# ***RUSSELL VALE COLLIERY***

## ***REVISED UNDERGROUND EXPANSION PROJECT***

### ***Extraction Plan - Upland Swamp Monitoring Plan***

**RVC EC PLN 008**

Figure 15 Performance TARP Process

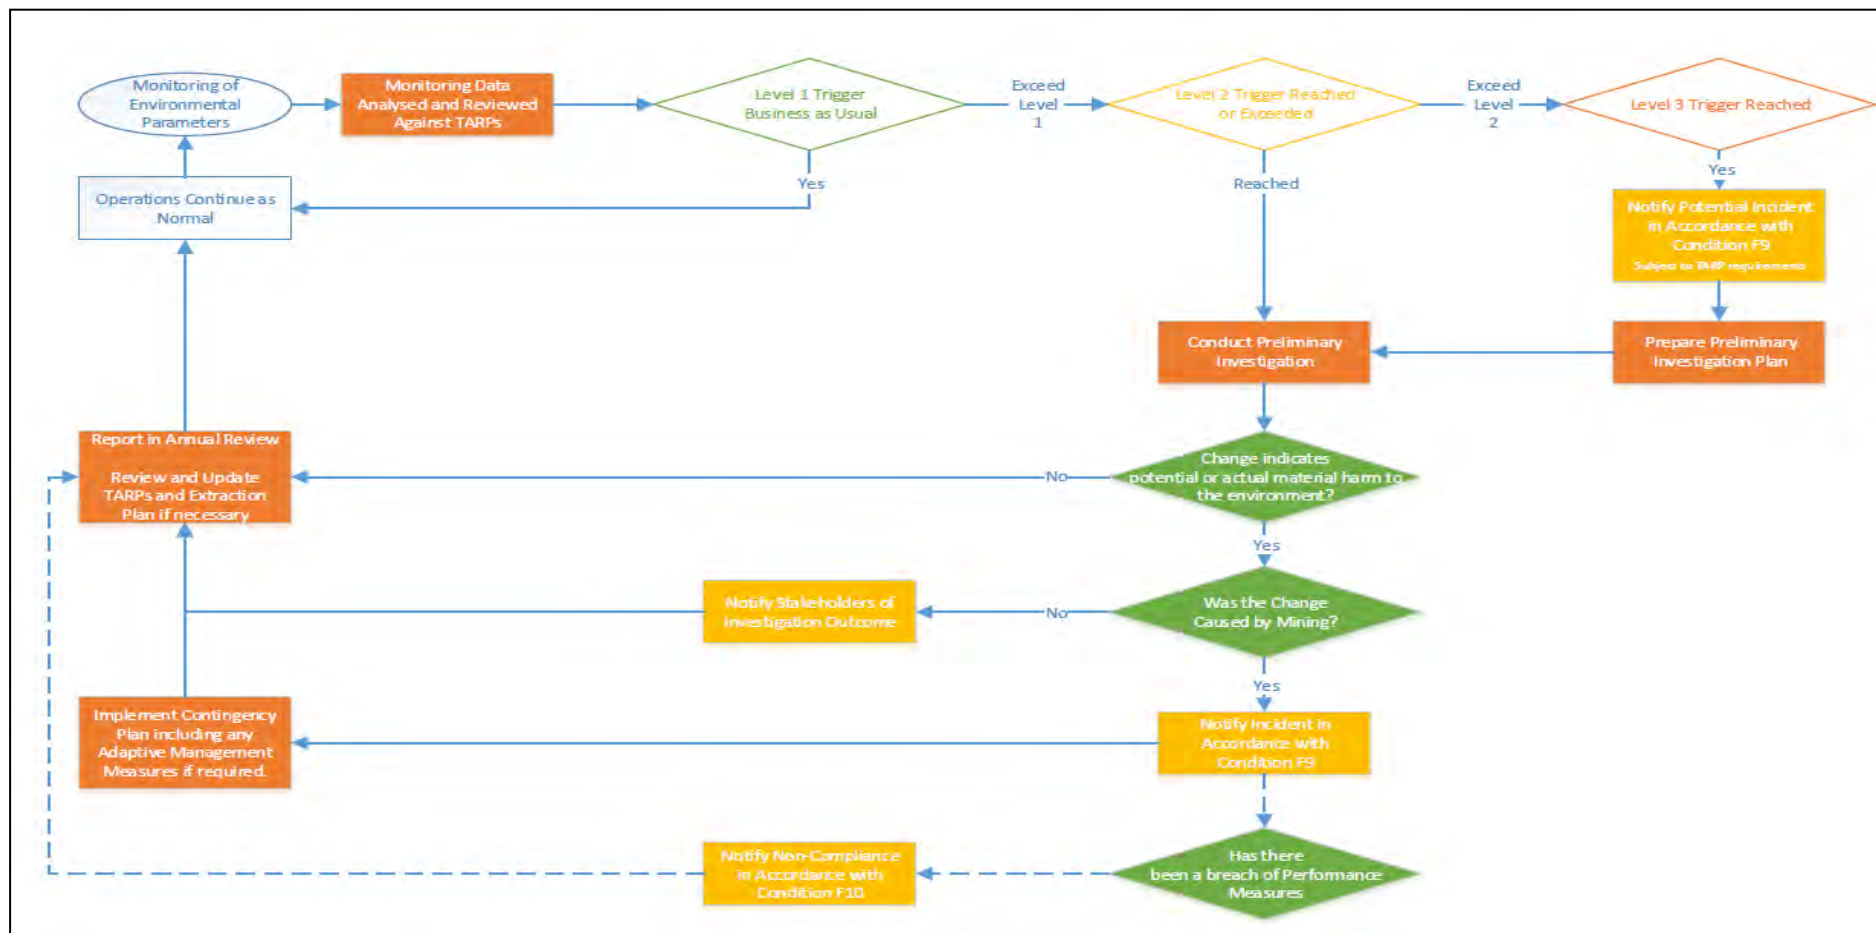
Consider including a dispute resolution step in the TARP for instances where there may be differing opinions in relation to the cause of any exceedance. Additionally, Figure 15 – Flow
